CNCL-24-55

Re: Maxwell Village Building Proposal - Report ED-24-42 Revised Applications to Amend Zoning By-law 60-94 and for Approval of a Draft Plan of Subdivision, Icon Harmony Limited, 1081 and 1093 Harmony Road North and 836 Pinecrest Road.

Re: Harmony Road Full Access Review

Location: 1081 and 1093 Harmony Road North and 836 Pinecrest Road, Oshawa, ON
Insured: Jane A. Clark
Your File: Pinecrest Infill Development
Our File: 230914TRA

Figure 1: Comparison of the reassigned generated traffic in our assessment with the estimate of the GHD traffic impact study.

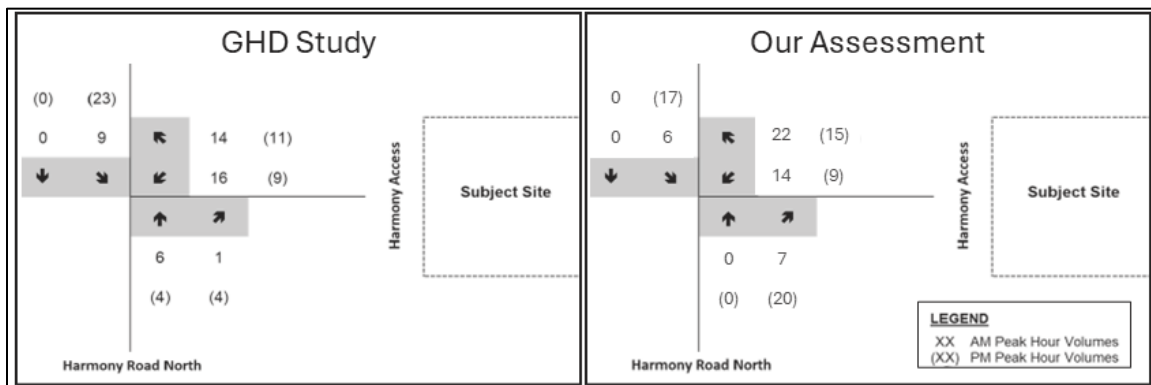
The traffic conditions were investigated in the GHD traffic impact study under three scenarios, including baseline conditions as estimated in 2022, in addition to 2024 and 2029 future projected volumes. The additional traffic generated by the proposed residential development was calculated and split between two access points, from Harmony Road and Pincrest Road. For the purpose of our assessment, the total generated traffic was reassigned at the Harmony Road access point (Figure 1). These traffic volumes were utilized to evaluate the access operations and design impact due to generated traffic on the operation of Harmony Road.

The total morning peak volume of generated traffic included a volume exiting the subject site of 22 vehicles (north) and 14 vehicles (south) and a volume entering the subject site of 6 vehicle (north) and 7 vehicles (south). The total afternoon peak volume of generated traffic included a volume exiting the subject site of 15 vehicles (North) and 9 vehicles (South) and a volume entering the subject site of 17 vehicles (north) and 20 vehicles (south). For the design of the southbound left turn going into the subject site, the maximum traffic of 17 trips was expected against the maximum opposing through traffic (northbound on Harmony Road), which included 1,596 vehicles per hour. This future traffic demand was used (Figure 2) to calculate the required left-turn storage length (including taper), as will be discussed in Section 3.2. Given the proposed development generates only 17 vehicles of left-turn demand in the southbound direction against 1,596 vehicles in the northbound direction, and the posted speed limit already reduced to 50 km/h (i.e., low traffic conditions), we conclude that this access will require a left-turn storage length (excluding taper) between 15 to 30 metres long. Further details on the design of the left-turn lane are provided in Section 3.2.

PROPOSED DESIGN SITE PLAN

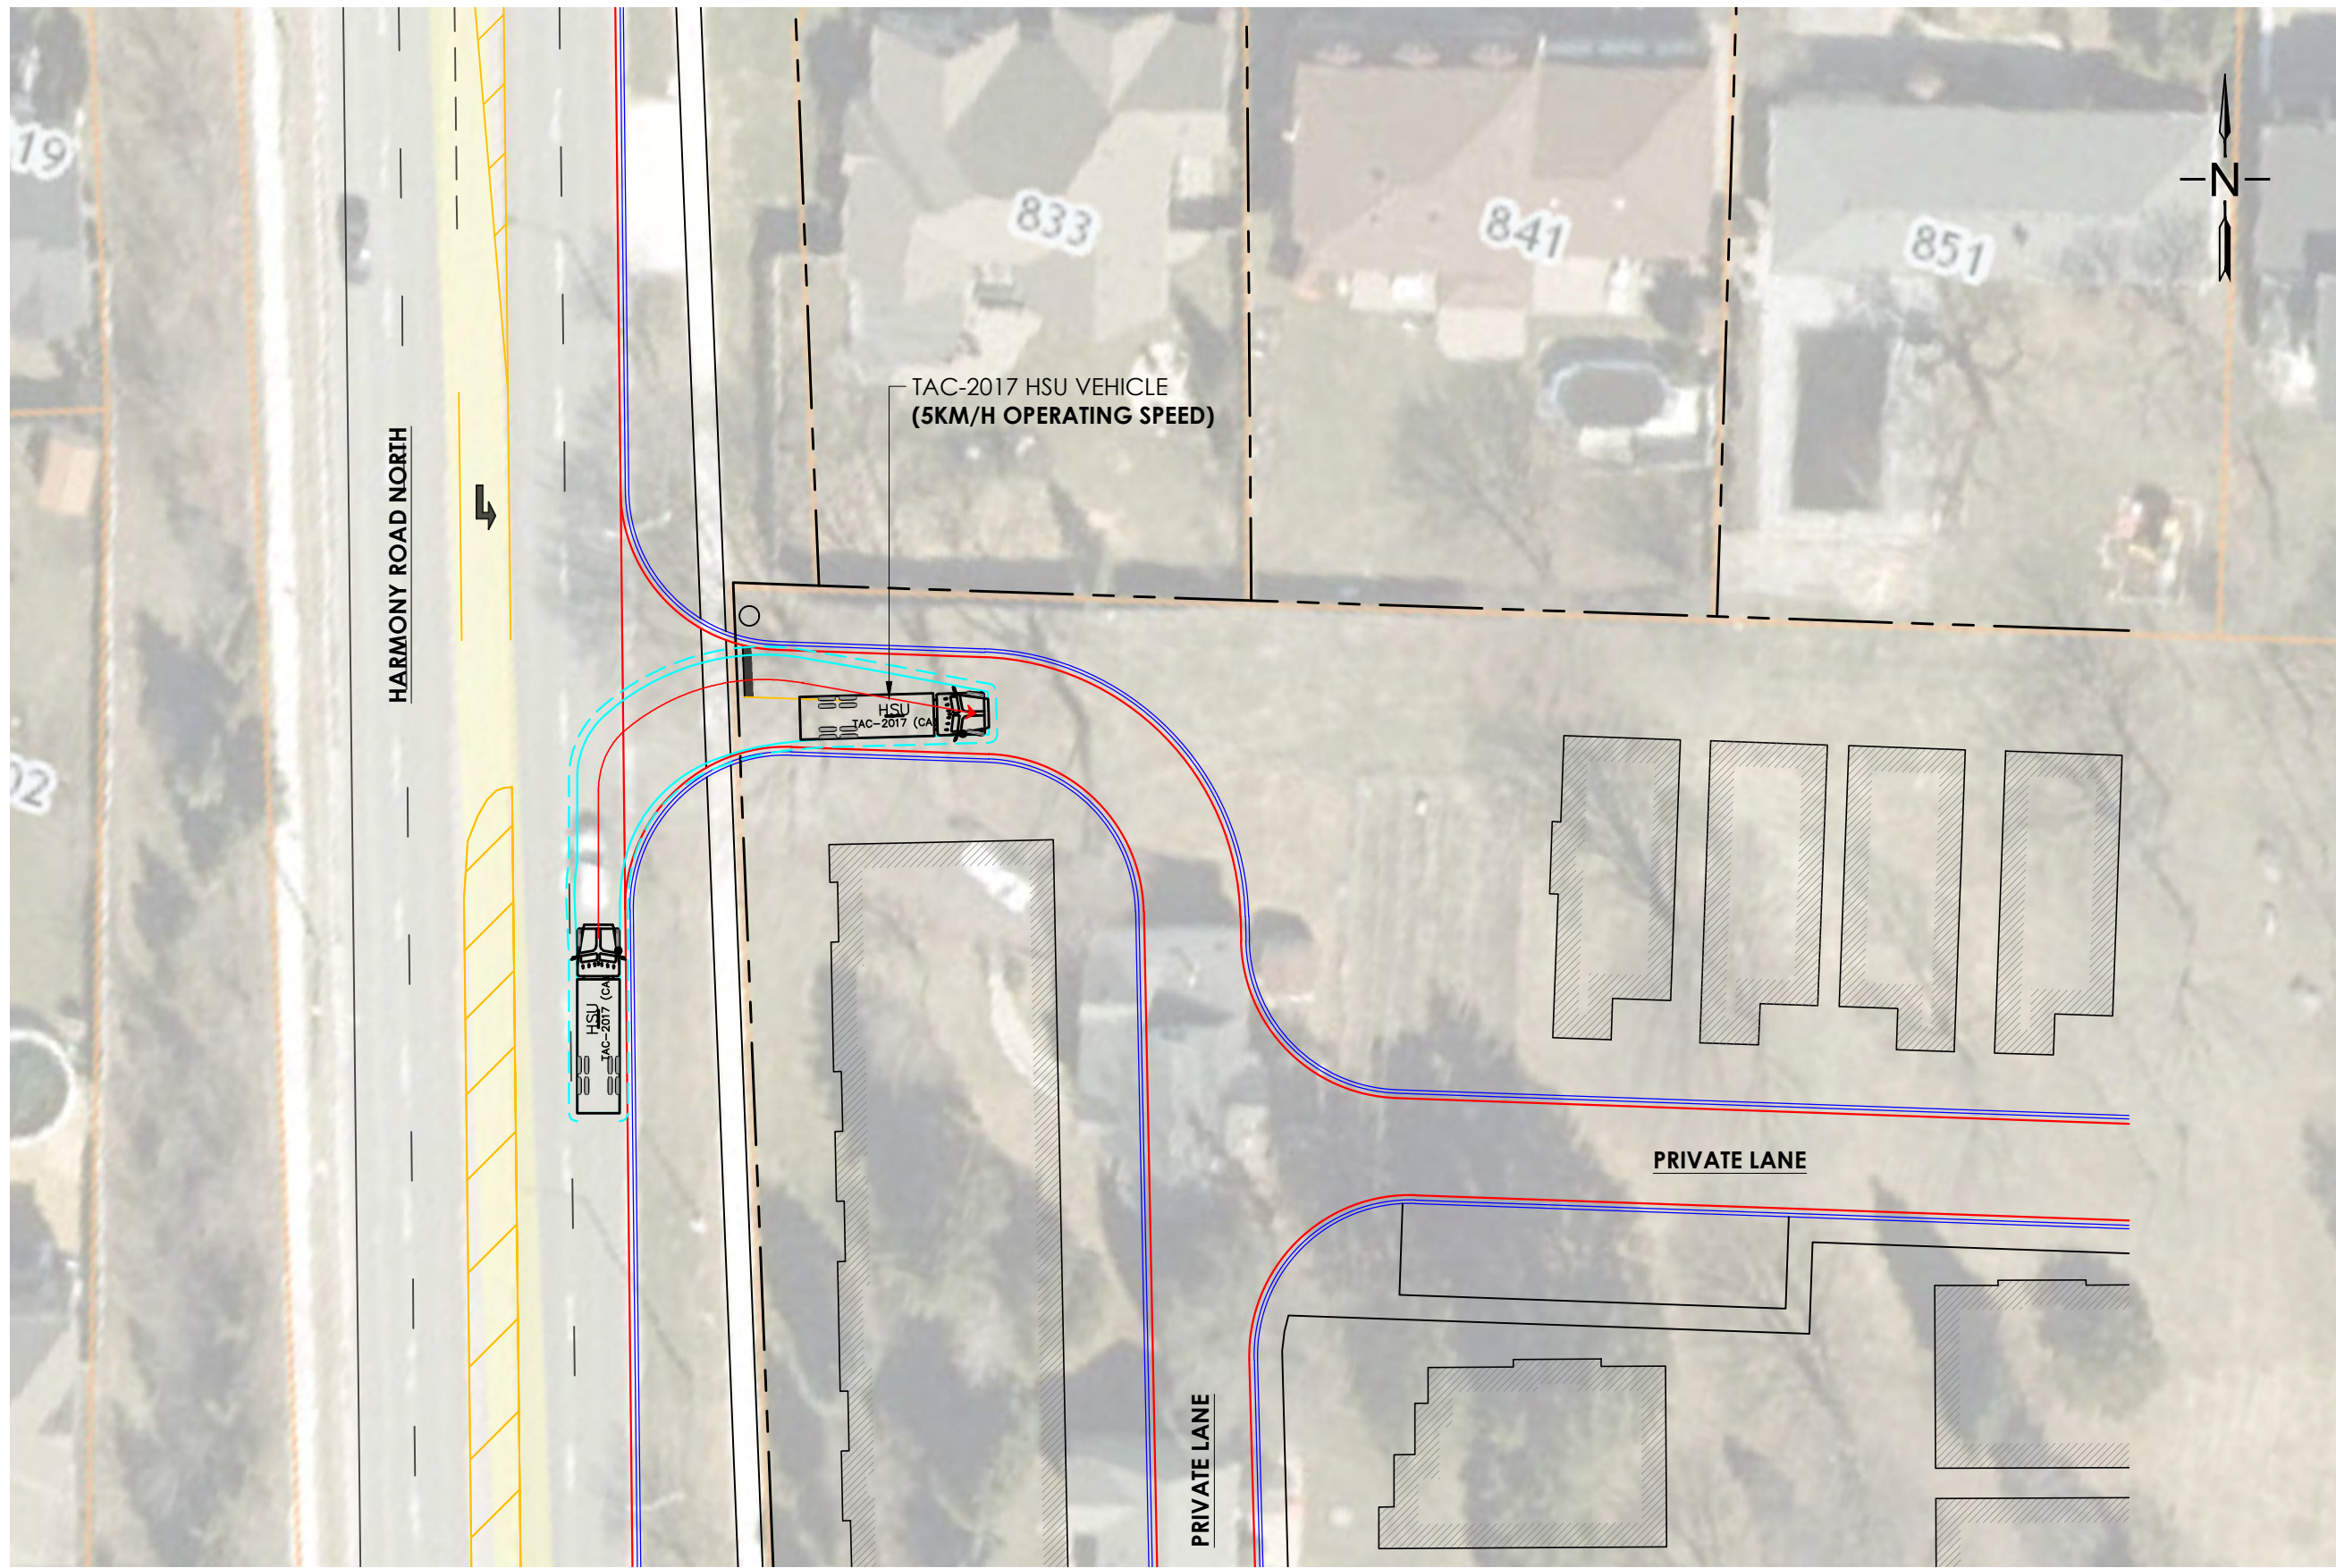
The proposed access from Harmony Road would effectively create a three-legged intersection controlled by a 'Stop' sign for westbound traffic exiting the residential development. The configuration of the proposed three-legged intersection at the Harmony Road access to the development allows for a reduced number of conflict points between the different vehicular movements. Specifically, the number of conflicts on three-legged 'T' intersections is nine, compared to 32 conflict points on traditional four-legged intersections.³ This indicates that the conflict potential of the proposed intersection on Harmony Road is expected to be minor, especially given the low generated traffic coming into and out of the development site (as outlined in Section 3.1). Vehicles travelling on Harmony Road would be able to access the residential development by turning right from the northbound approach or left from the southbound approach. Our access review analyzed the following features and made the following conclusions:

Design of left-turn Lane: The existing roadway geometry can accommodate a standard left-turn lane for southbound inbound traffic, with a lane width of 3 metres, while maintaining the 3.4-metre widths of the existing four lanes on Harmony Road. The 3-metre lane width (for through travel lane)⁴ satisfies the recommended lower limit for urban roadways with a design speed of 60 km/h or less, according to the Transportation Association of Canada's Geometric Design Guide for Canadian Roads (the 'TAC guideline').⁵ This configuration is consistent with left-turn lane design options provided in the GHD traffic impact study (page 30, Figure 15 or 16).

Configuration of southbound left-turn lane and intersection proximity: The recommended storage length is 30 metres per the GHD traffic impact study. However, given very low traffic demand, the minimum storage length recommended by the MTO guideline is sufficient given urban conditions and low left-turn demand. This required storage length for the southbound left-turn lane is generally sufficient to accommodate two vehicles⁶ (required 14 metres) or one large design vehicle/truck (roughly 11.5 metres long), with a minimum parallel lane storage of 15 metres. Note that the left-turn demand for this turning movement is only 17 vehicles per hour, i.e., roughly one vehicle every 3 or 4 minutes. This indicates that a two-vehicle storage would be sufficient to accommodate the traffic demand for this development. Given that there is no connection to the neighborhood, this turning demand will not increase in future. In addition, a taper length of 40 metres is sufficient to accommodate the transition from the existing two southbound lanes of Harmony Road into the proposed left-turn lane at the access road. As a result, the combined required length of 55 metres must be provided. This length maintains sufficiently safe distance from the nearest intersection with Swiss Heights and does not interfere or encroach upon the safety or operations at the Swiss Heights intersection.

1 VEHICLE TURNING ASSESSMENT - RIGHT TURN
 SK.2 INTO PRIVATE LANE

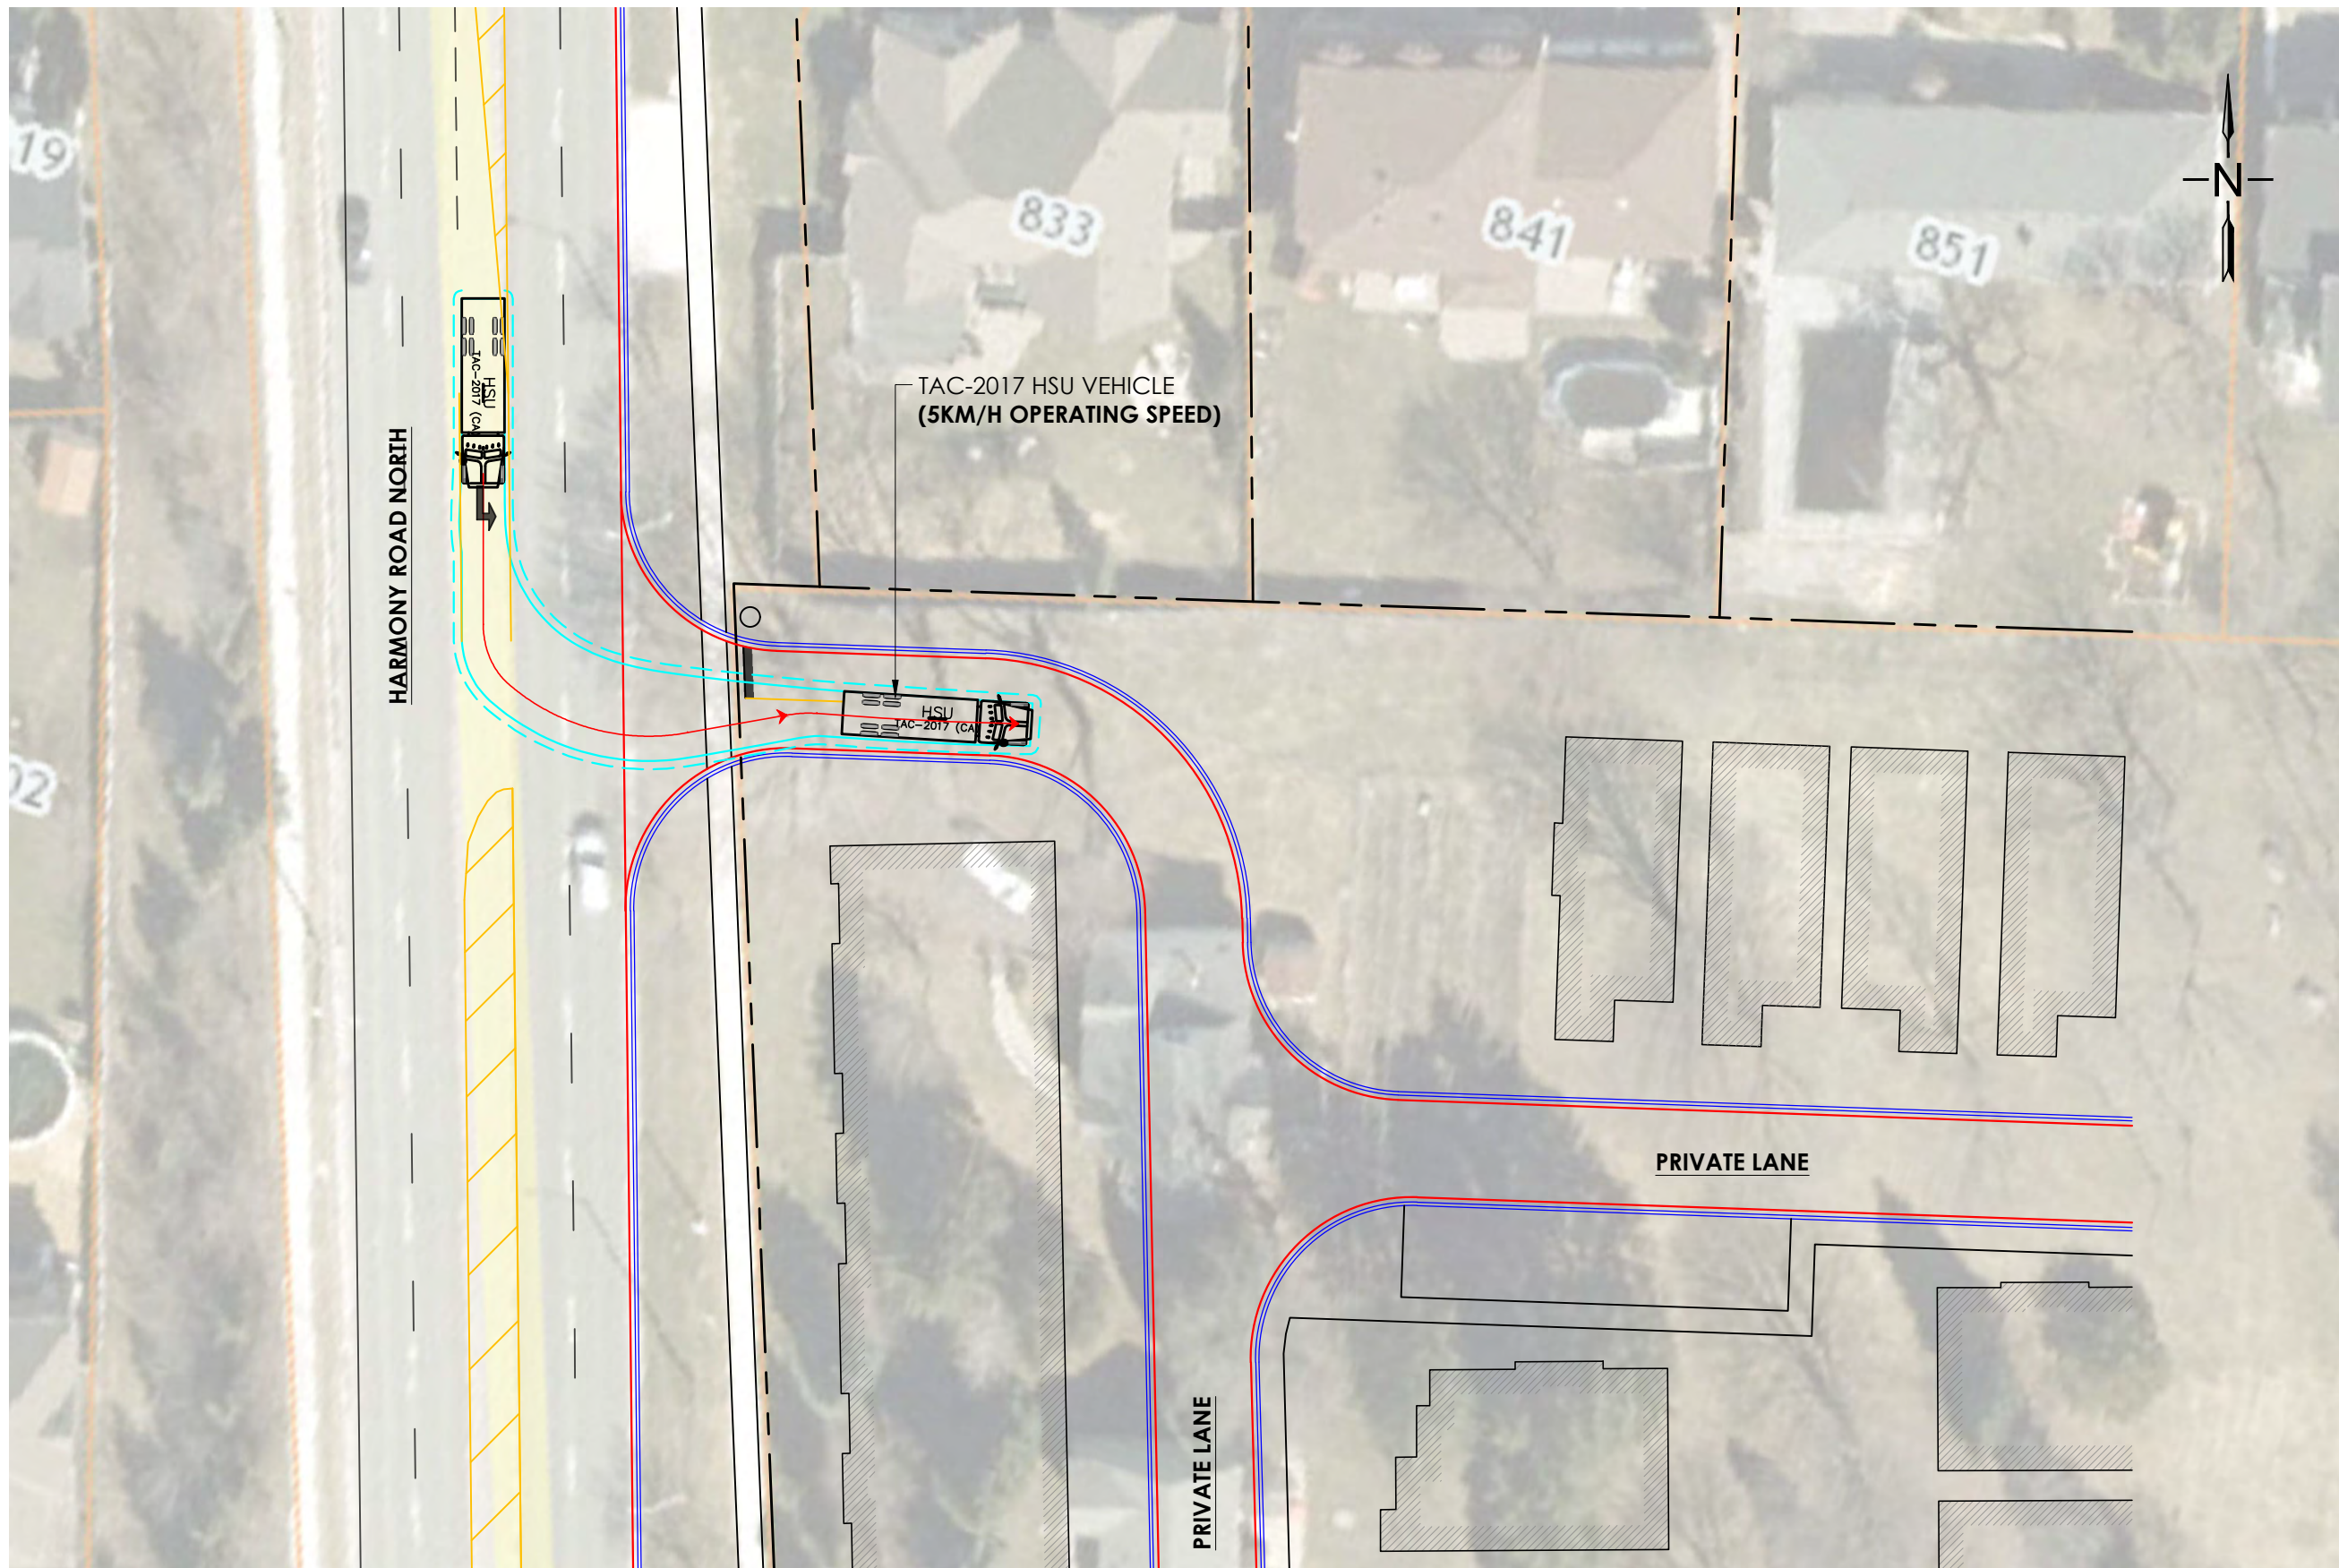
The swept path analysis confirmed that the proposed driveway width (roughly 6.0 meters), corner radius (roughly 9.5 metres), and stop sign location were sufficient to accommodate all critical movement to accommodate the design vehicle. Turning movements provide sufficient safety buffer distance (0.5 metres) from fixed objects, and vehicles are able to turn safely without encroaching on fixed objects such as raised curbs. These turning movements (such as encroaching on opposing lanes on local driveway or roads) are aligned with the provincial allowance for large vehicle movements.
